## **Recall Inspection and Repair Instructions**

NHTSA Recall # 24V-036

**Tiffin Motorhomes Recall #** TIF-135

**Models Involved**: 2022 Allegro Bus Motorhomes, 2022 Phaeton Motorhomes, 2022 Allegro RED 360 Motorhomes, and 2022 Zephyr motorhomes built between January 3, 2022, and April 28, 2022.

Figure 1

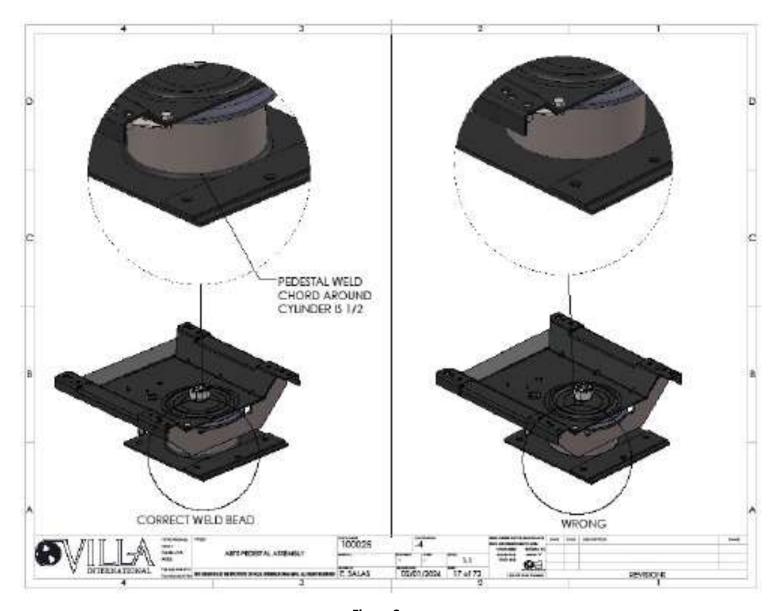
1. Inspect the driver's side seat pedestal to verify the weld is complete around the base of the seat pedestal. See Figure 1 and 2 below to help determine if the weld is correct or not.

- 2. If the weld is complete around the entire pedestal base, there is no further work to be done.
- 3. If the weld is missing, please take a picture and email to <a href="missing"><u>jim@villainternational.com</u></a> for authorization to replace the seat base and to order a new part.
